NAVAL MEDICAL RESEARCH INST BETHESDA MD
A PRELIMINARY HUMAN ENGINEERING EVALUATION OF HYPERBARIC CONTRO--ETC(U)
MAR 77 W W BANKS, D M HEANEY, A J BACHRACH

A PRELIMINARY HUMAN ENGINEERING EVALUATION
OF HYPERBARIC CONTROL SYSTEMS

Research Subtask M0099-PN.03-3022

March 1977

Fig. 9. Gas control farm #3007875 exemplifies a situation where components are susceptible to operator impact and poor visual access.

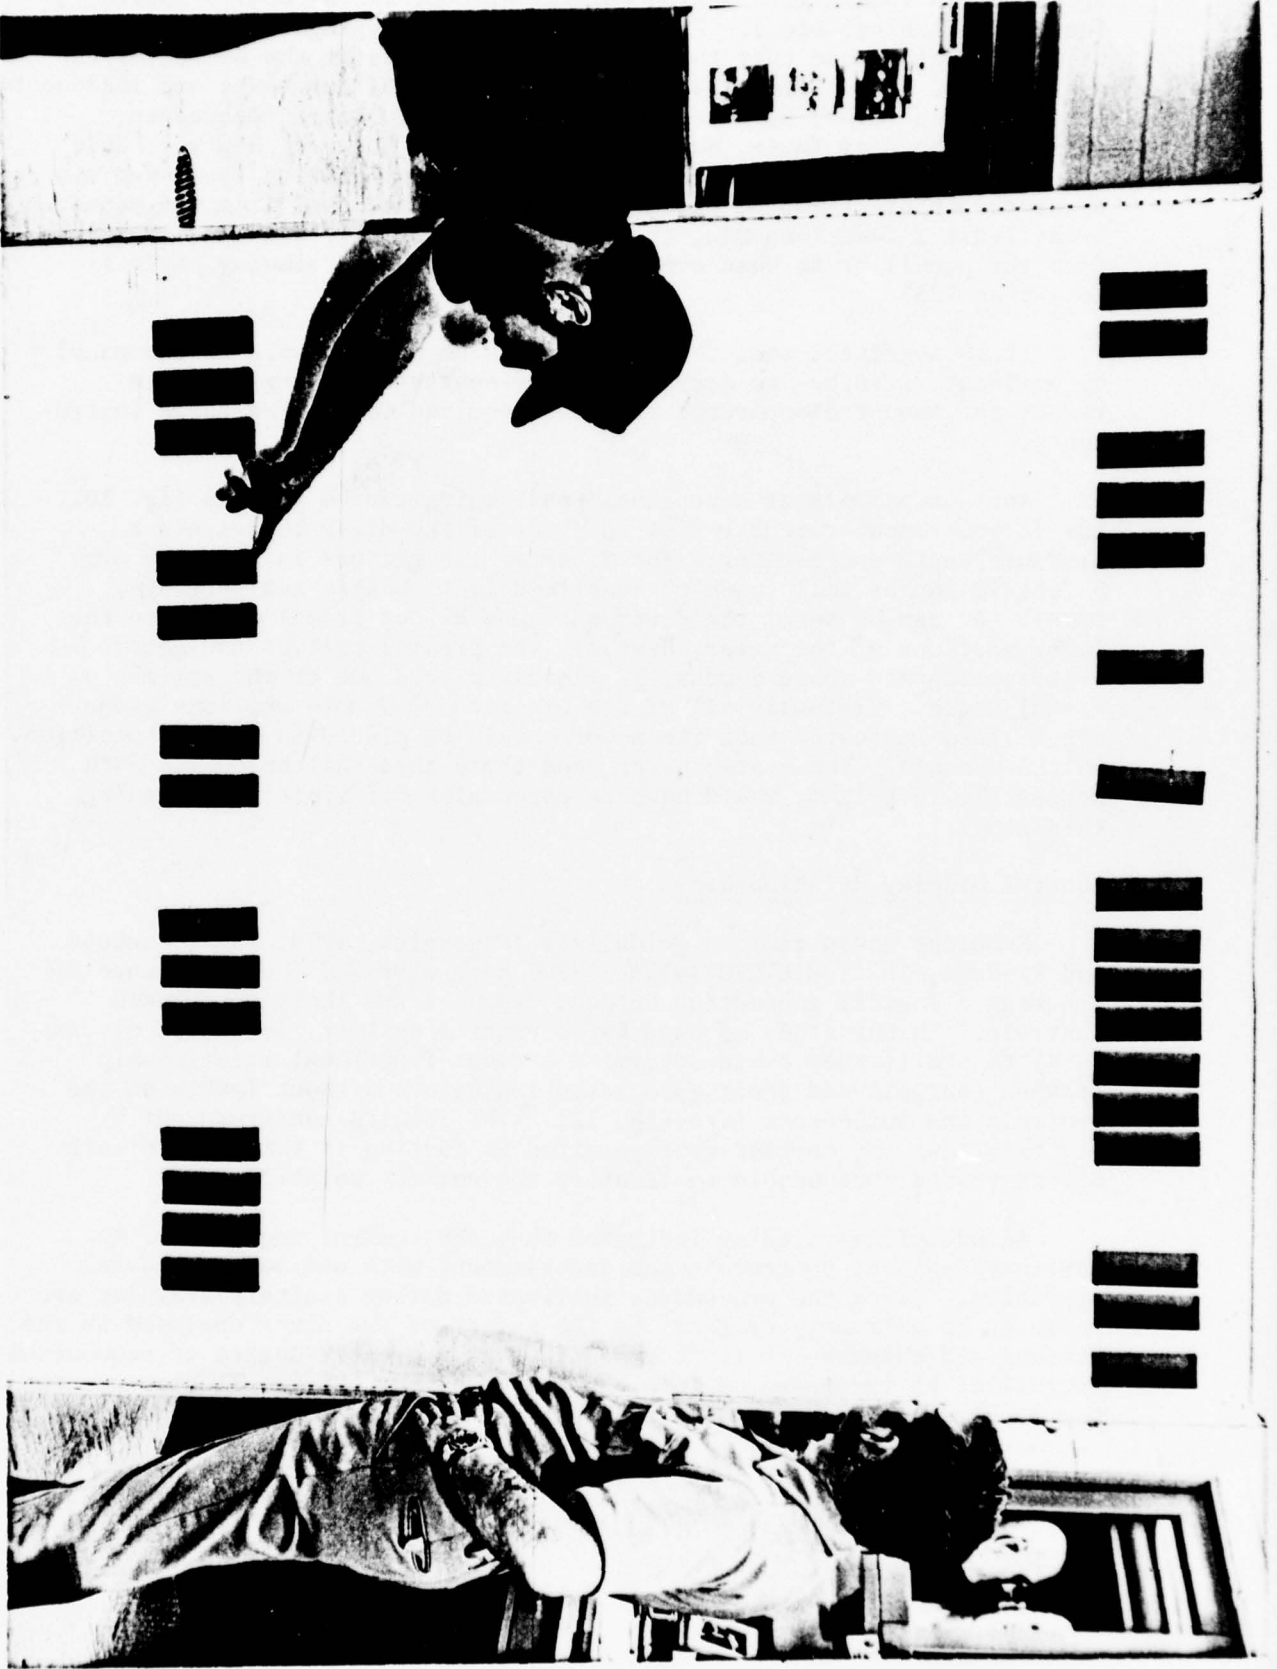
Tests were conducted to learn whether the hyperbaric gas-storage panel (Fig. 9) could meet this requirement and whether it would allow operators to locate information quickly without excess bodily motion (bending, turning, etc.). Figure 9 offers a photographic frontal view of this panel. Note that the indicator components at the bottom of the panel are 12 inches from the deck. The results of our tests are inadequate at the present time, because we did not have information needed to construct the dial faces, numbers, and scales. We were, however, able to determine that direct visual access to the information presented via these components required operators either to back away from the panel by at least 2 feet (assuming the operator is normally standing 12 inches from the panel) or to bend over to a point where the viewing angle is less than 125°.

It is suggested that these components be moved upward on the panel by at least 21 inches to decrease the present viewing angle and to reduce the amount of operator movement required to examine these instruments.

Fig. 10. The large, round pressure meters are located too high on the control panel for optimizing the operator's viewing field. (The human operator is 5 ft 10 inches tall.)

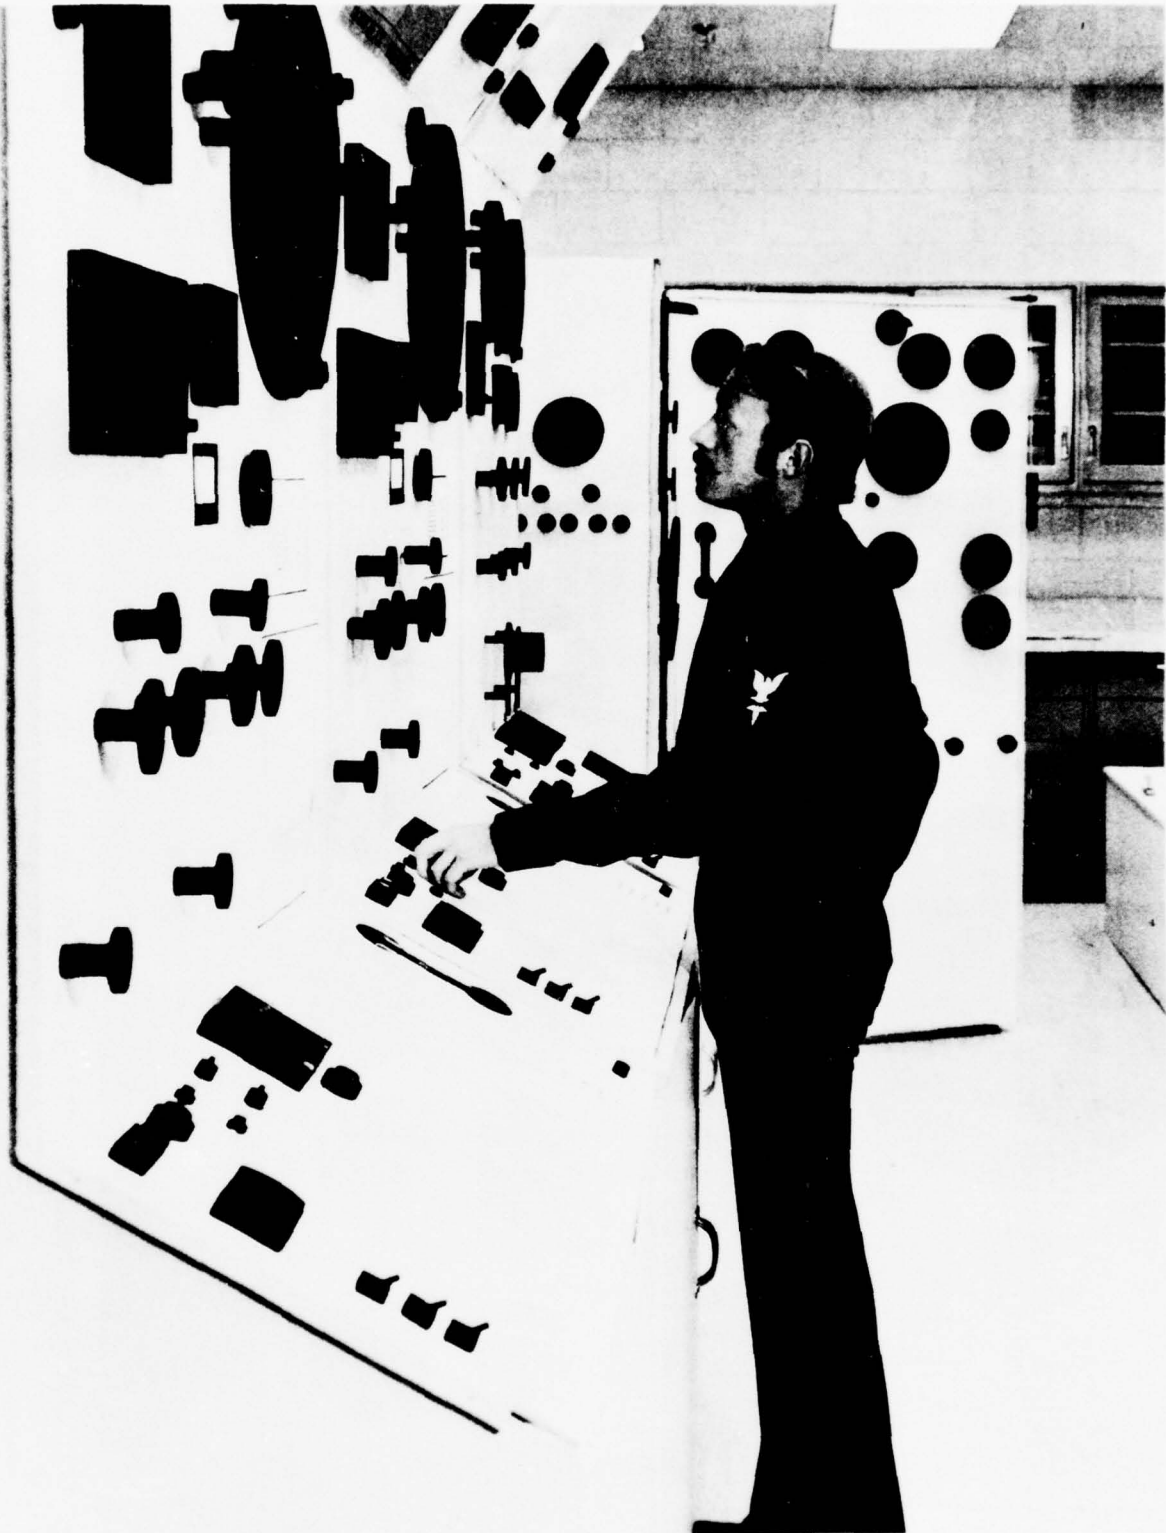
Another example of suboptimal positioning can be seen in Fig. 10. The large, round, circular disk in front of the diver represents a pressure/depth gauge meter. The diver in the picture is slightly over 5 feet 10 inches tall (65th percentile-height, Beatty and Berghage, 1972). As can be seen, the diver has good direct visual access to the lower portions of the meter, however, the greater part of the meter, representing mid-range depths, is clearly placed out of the optimal visual angle. Virtually all of the experienced divers who were given check lists indicated that the meter should be placed in a lower position on the console. The seated diver, and those that fall below the 50th percentile in height, would have an especially difficult time reading this gauge.

Fig. 11. Side panel local #3007874 is used for sanitary draining. Control/indicator relationships are vague.

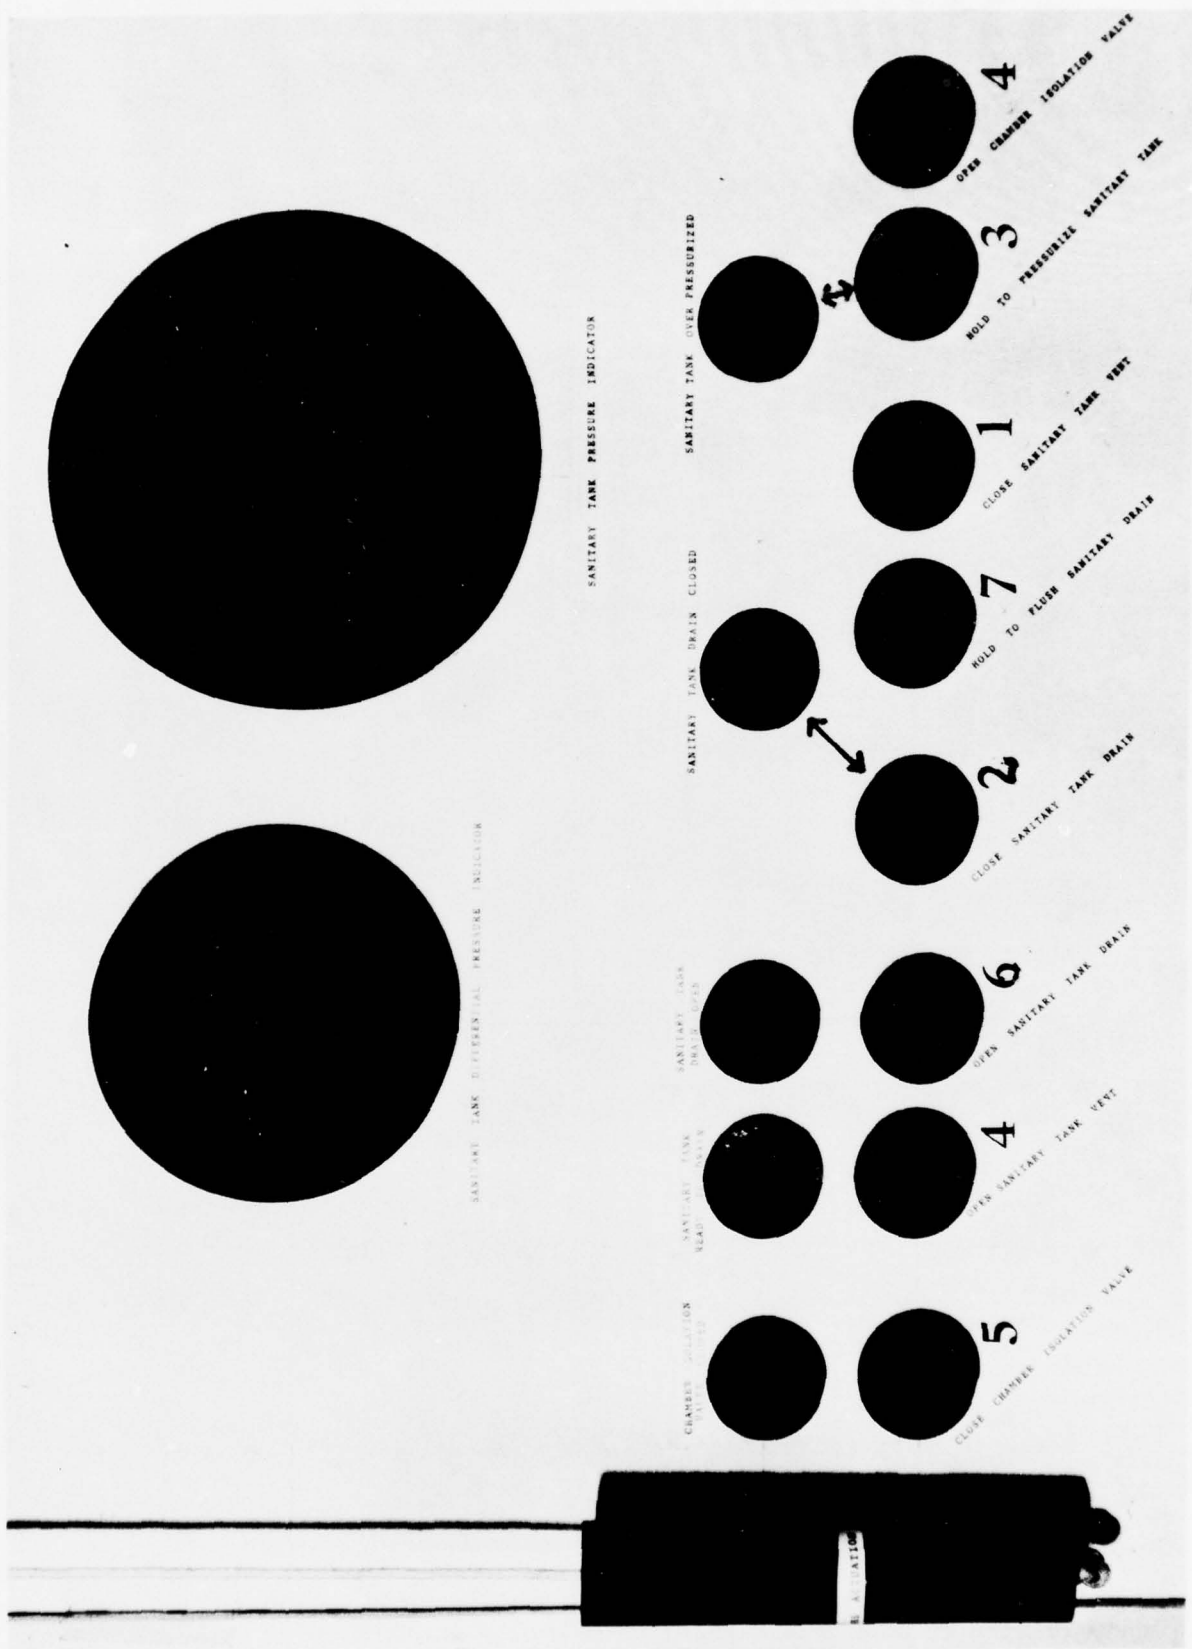
An additional finding indicated that the control sequence of the sanitary draining components was inconsistent with defined procedural operation. Since the procedures instituted during sanitary draining are known to be extremely critical to the safety of the diver enclosed in the pressurized chamber, it is recommended that a greater degree of sequential compatibility be incorporated into the panel design. Figure 11 displays the side of the local panel that contains the sanitary draining controls. Note the

numbers located just below each control button. The numbers represent the sequence of control actions employed during a sanitary draining procedure. It would be far better for an operator to move through this sequence in a smooth left-to-right direction. This could be accomplished by placing the sanitary-tank vent close control on the far left, followed by the sanitary-tank drain close control, pressurization control, and so on, until finally control #7 would be placed on the far right of the panel, at the position now labeled #4.

The arrows in Fig. 11 are pointing toward control lights and their associated activation buttons. Notice that two of the lights are not aligned with the appropriate activation button. These existing relationships between control and display should be made more explicit. It is further recommended that controls associated with valve-closing procedures be clearly distinguished from those controlling valve openings. The reasoning for this recommendation is obvious when one considers the consequence of inadvertently opening a low-pressure line when the sanitary tank is under pressure.

Fig. 12. The relative position of the fire emergency lanyard is shown. Note its proximity to the working environment.

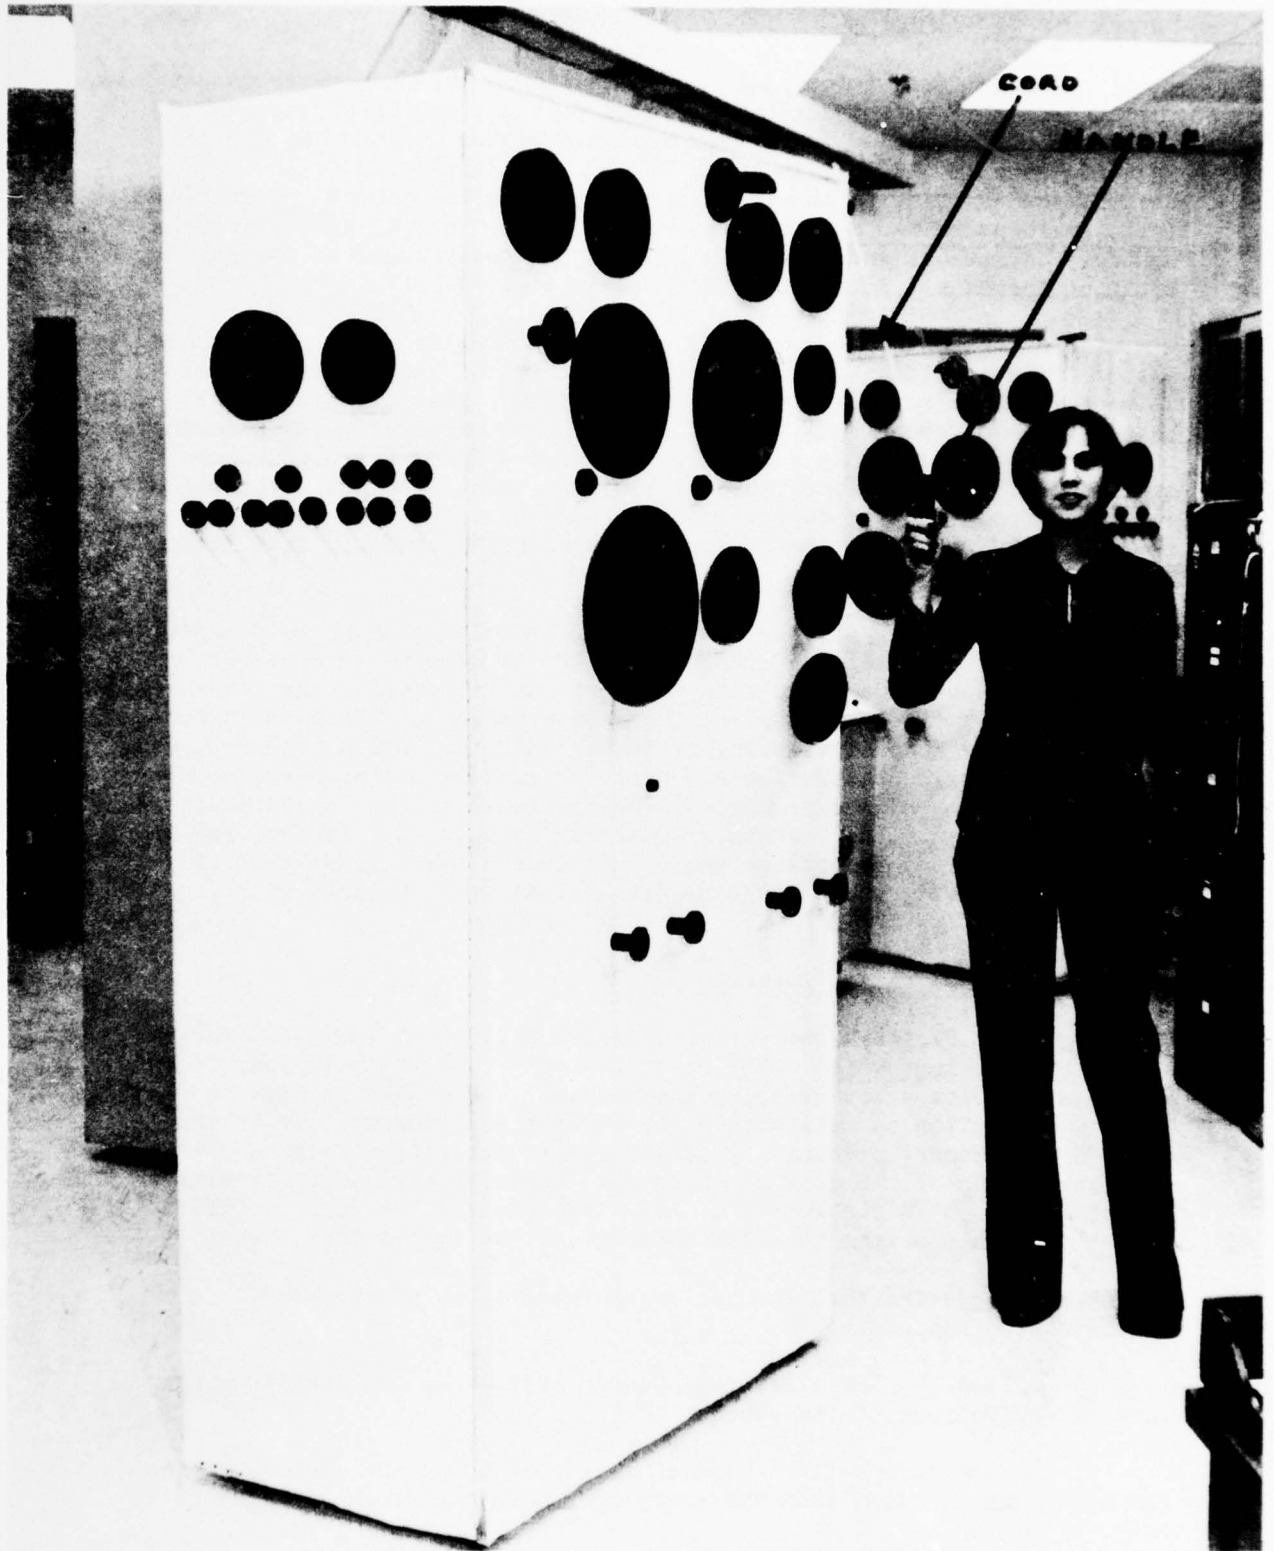
Figure 12 displays the fire-extinguish activation lanyard. The fire-extinguishing system (FES) is activated by pulling this lanyard in a downward motion after grasping the handle. The handle is free to swing and is situated well within the working environment. It is thus exposed to a higher probability of accidental activation because of the swinging motion of the cord to which the handle is attached. It will be important for us in the future to have knowledge of the force required to activate this system in order to address this system more adequately.

We make these recommendations because seven of the eight divers tested considered the current configuration undesirable. Furthermore, human factors engineering guidelines (VanCott and Kinkade, 1972) stress that accidental activation of emergency equipment should be reduced to an absolute minimum.

It is suggested that the following changes be incorporated to remedy these problems.

1. Place the FES activation handle further up and away from the working environment of the panel.
2. Substitute a fixed-handle, single-motion lever instead of the lanyard so as to allow easy emergency operation and prevent accidental activation.

3. Locate the FES actuation arm at the front-top of the panel and clearly mark it.

Fig. 13. Example of poor task-loading decision.

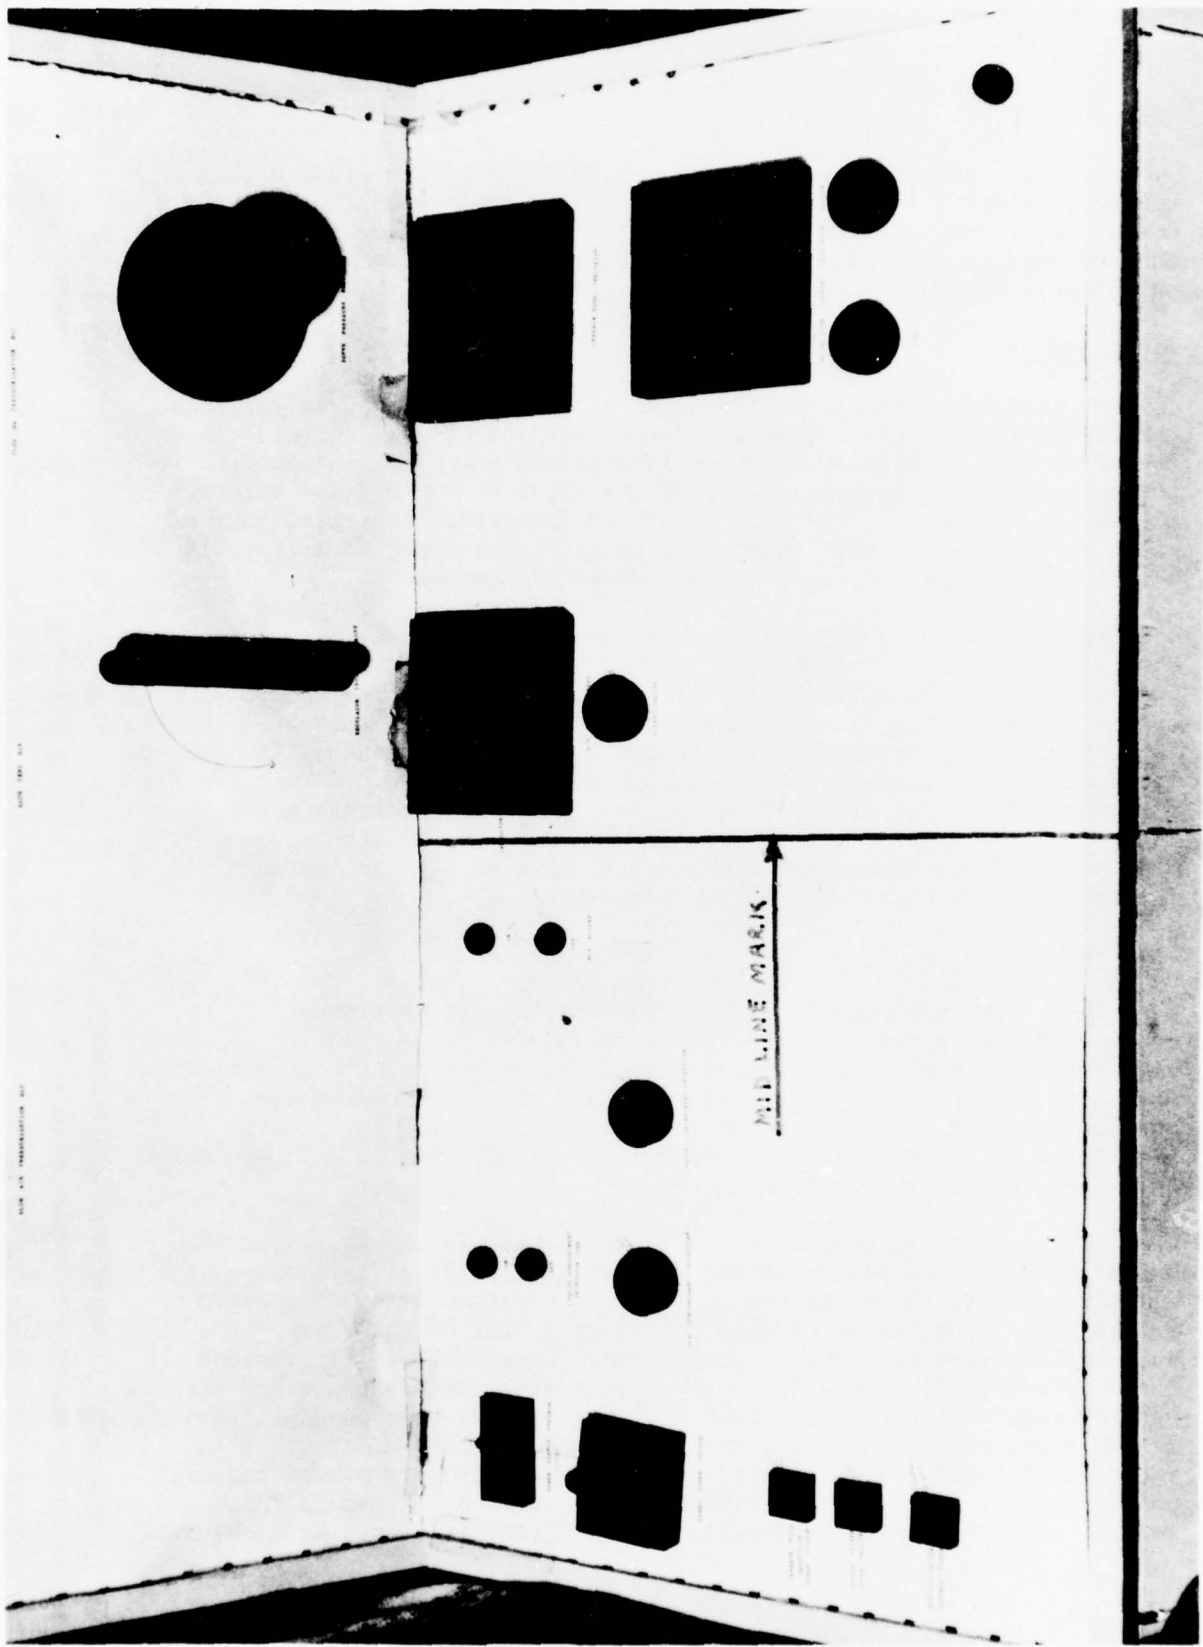
Military specifications for human engineering designs specify that console designs should allocate a larger portion of the control task to the operator's right hand. Figure 13 displays a control panel with three functional controls located to the right of the midline mark of the panel. To the left of midline are 11 functional controls, most of which are power-related. This configuration would only be acceptable if all or most of the control operators were left-handed.
